APPLICATION FOR SITE PLAN APPROVAL

Modification of Approved Site Plan
House Addition at 300 Between the Lakes Road

NEW ADDITION 300 BETWEEN THE LAKES ROAD

PROJECT	NEW ADDITION		
	300 BETWEEN THE LAKES ROAD - SALISBURY, CONNECTICUT

SITE PLAN

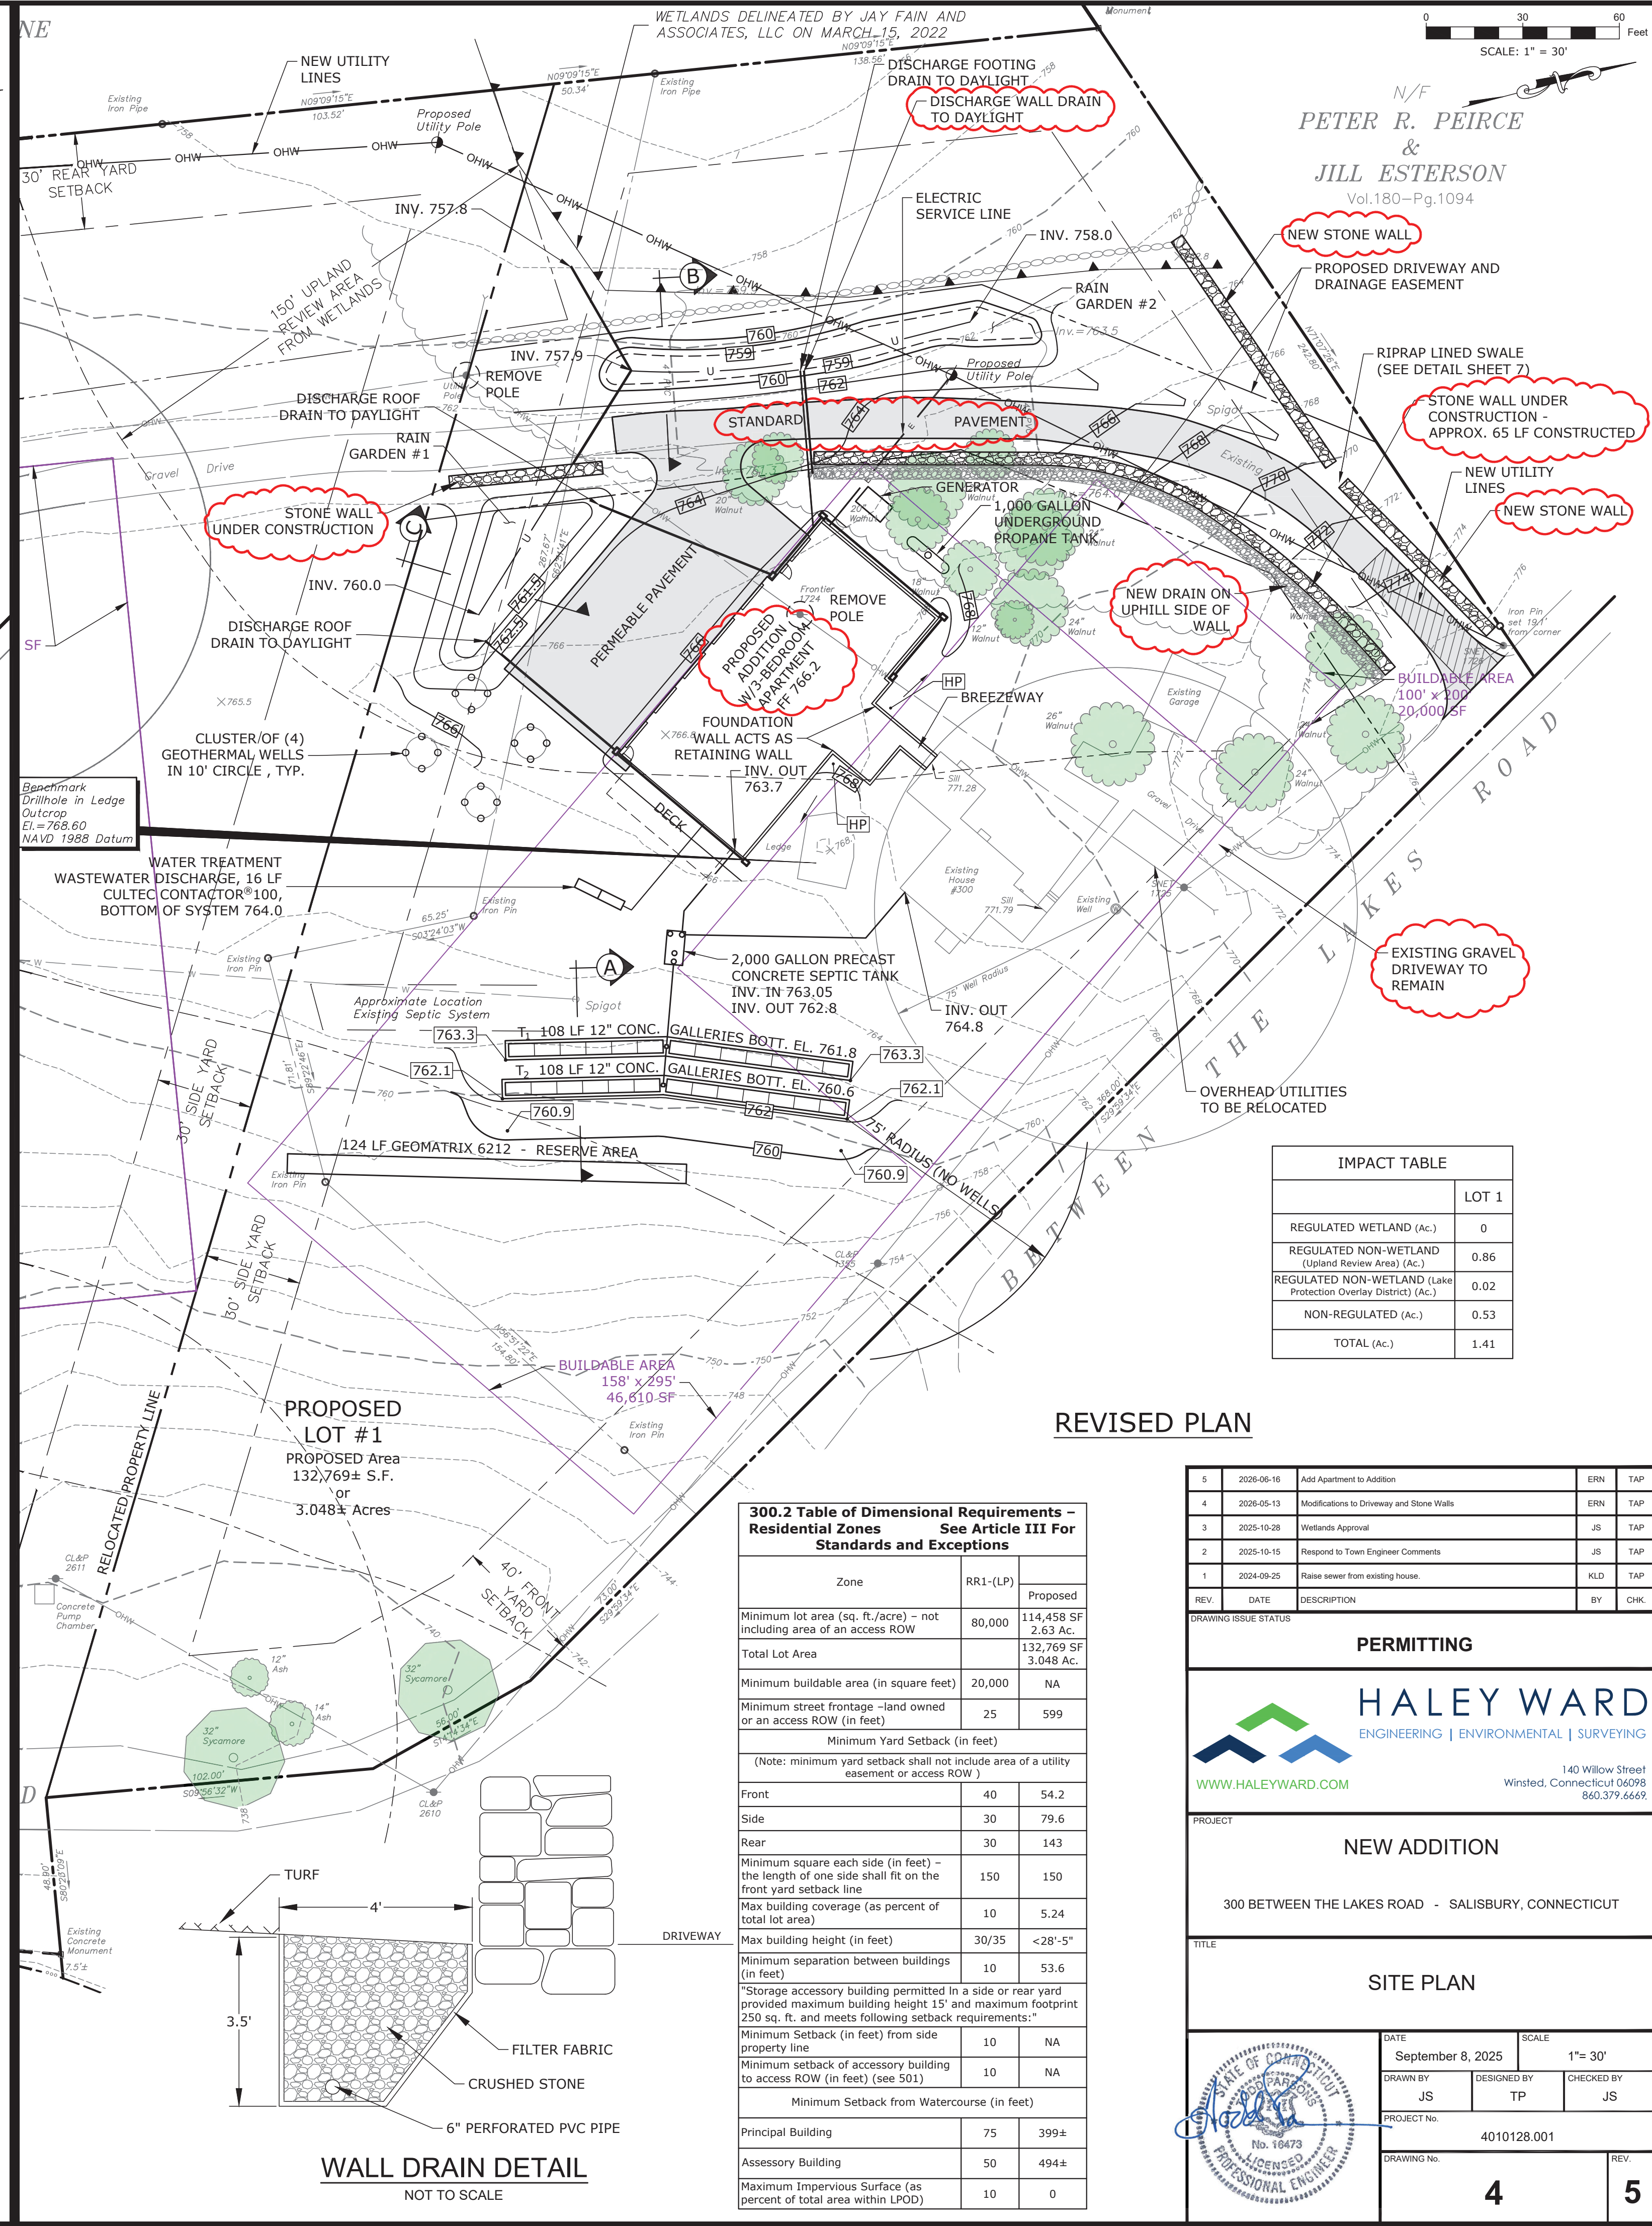
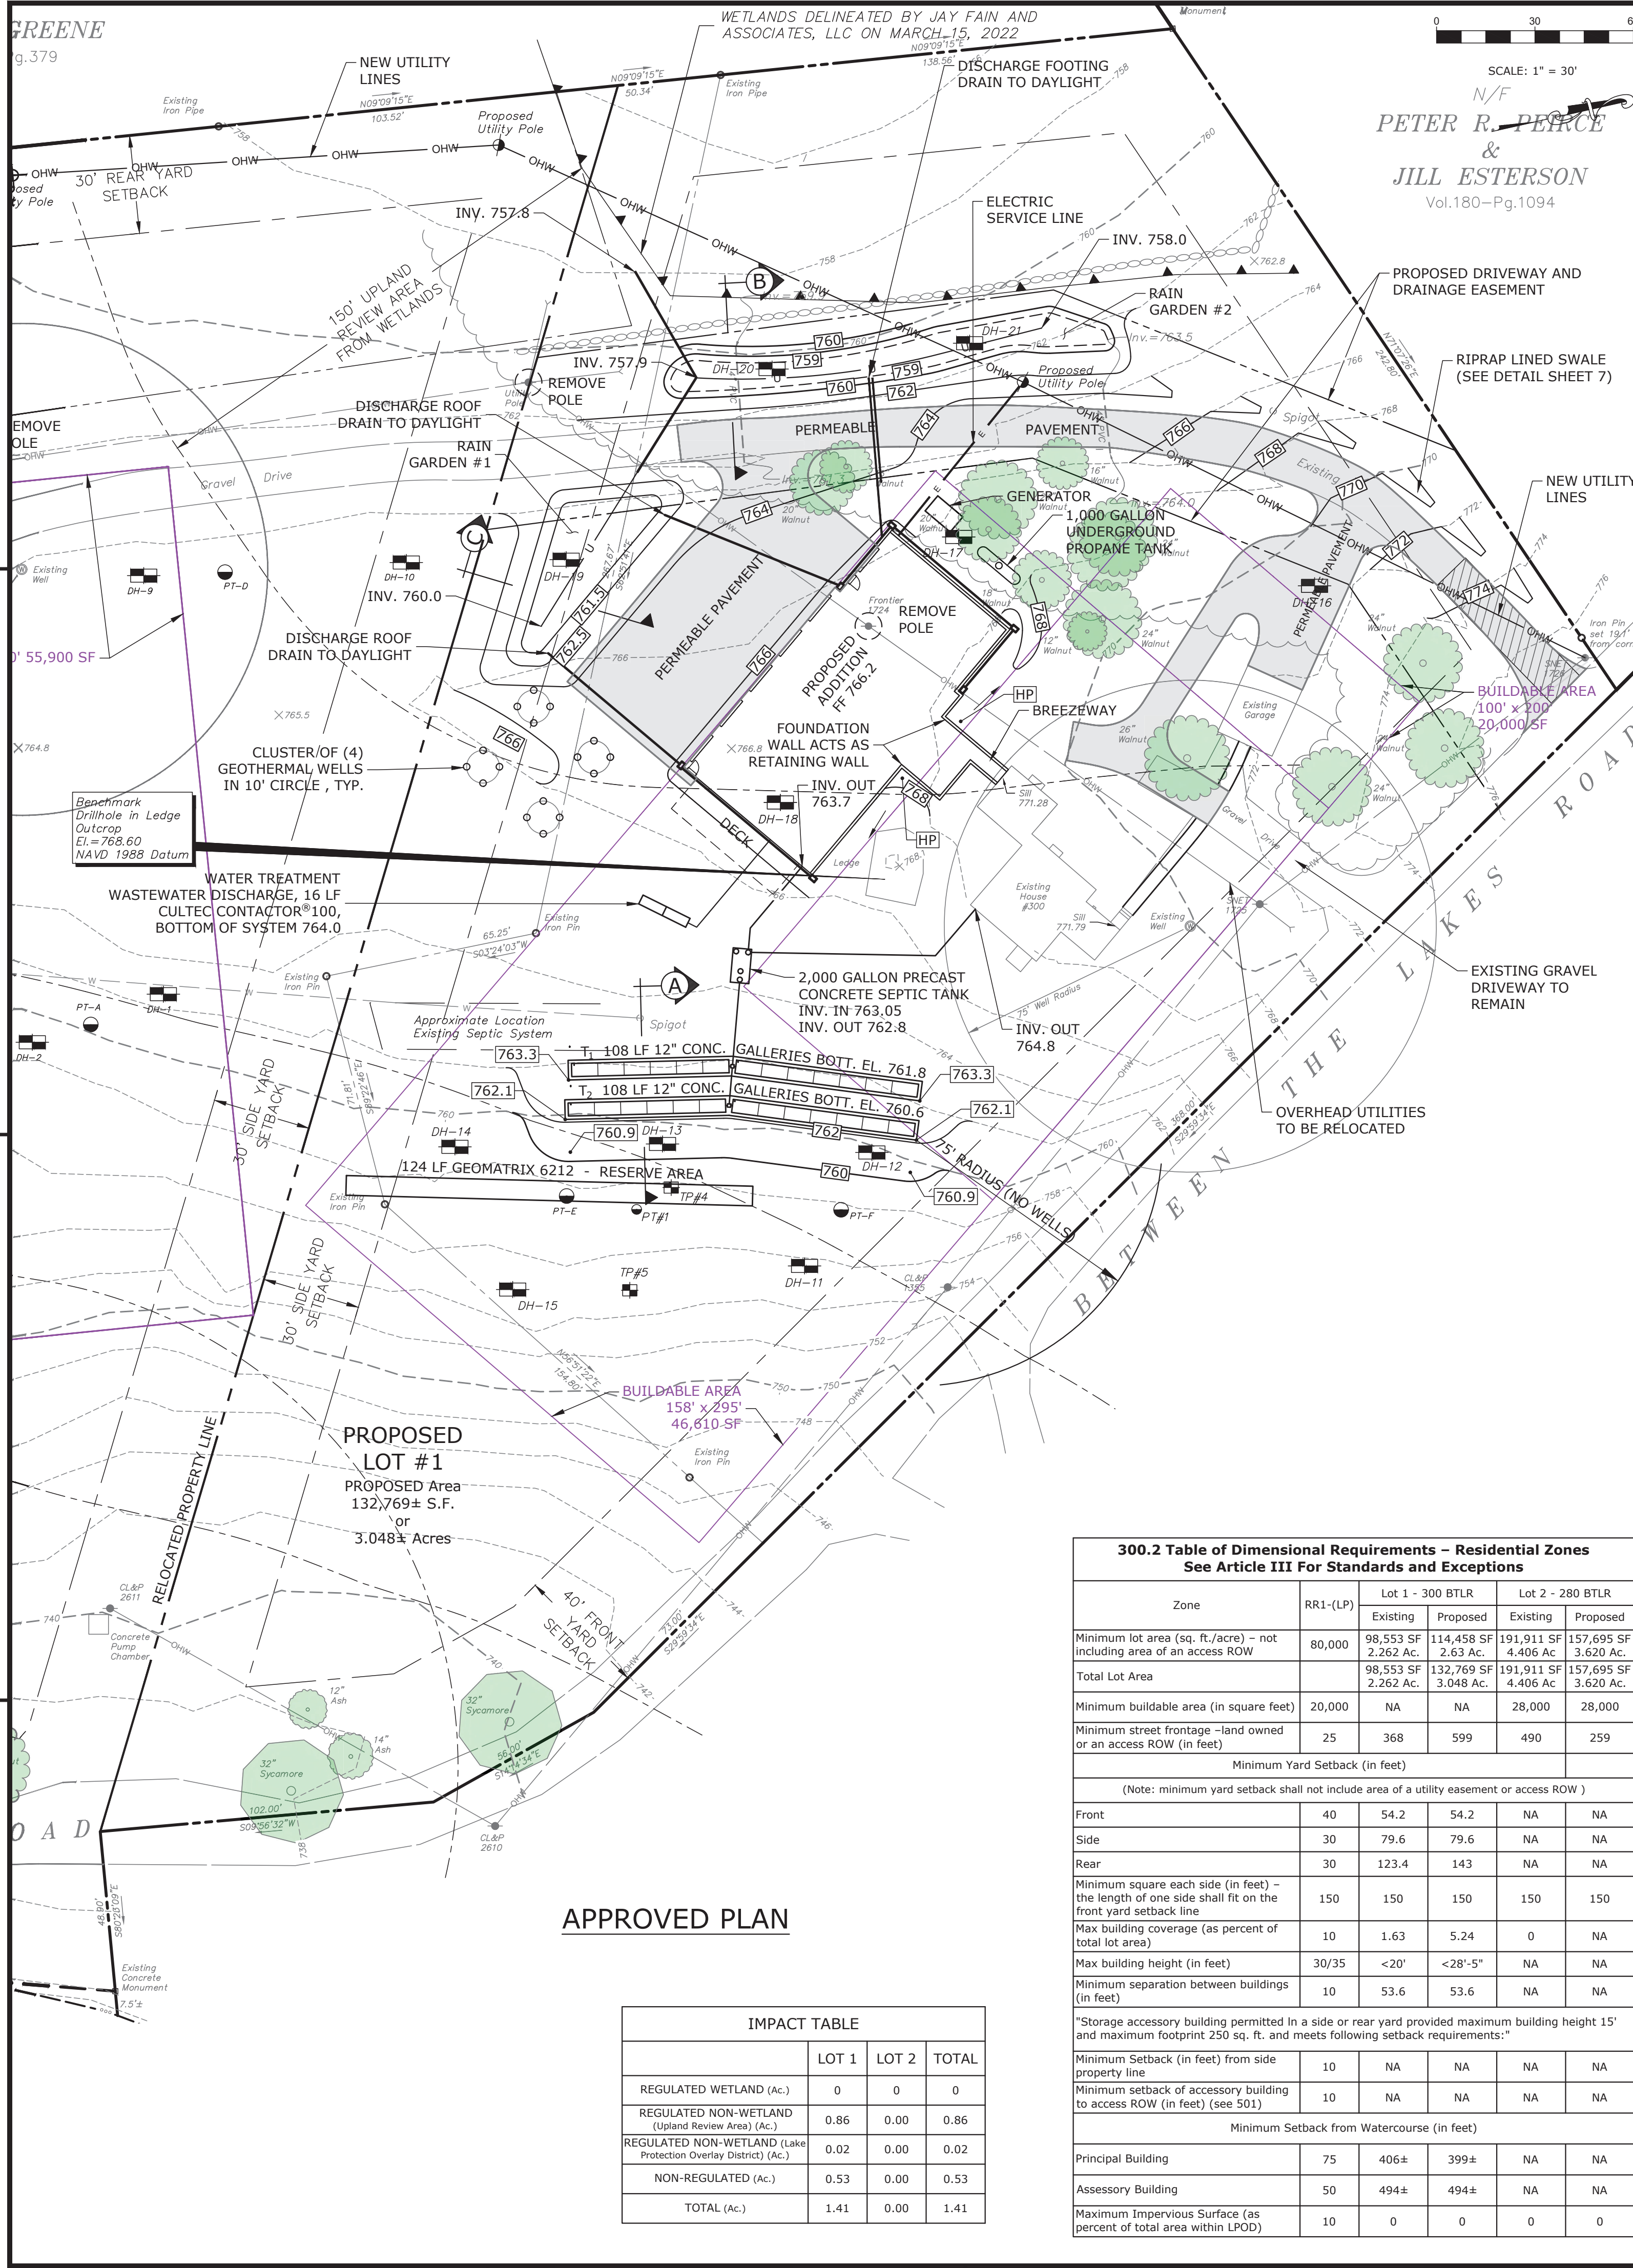
1. Eliminate the portion of the new driveway leading to the existing garage and leave the existing driveway to the existing garage in place.
2. Construct new stone walls on both sides of the new driveway.
3. Install a new drain on the uphill (south) side of one of the stone walls to collect runoff and discharge it to proposed Rain Garden #2.
4. Change a portion of the driveway from permeable pavement to standard pavement.
5. Build a three-bedroom apartment in the addition. The footprint of the addition will not change.

The modifications are shown on the attached site plan and highlighted by red revision bubbles. We also note the following:

1. The septic system is not affected as the TAHD approval includes the apartment in the addition.
2. The rain garden sizes are not impacted as the original design calculated all paved areas as impervious. Rain Garden #2 has been shifted slightly to the south to accommodate the stone wall along the driveway.
3. None of the modifications occur within the Lake Protective Overlay District.
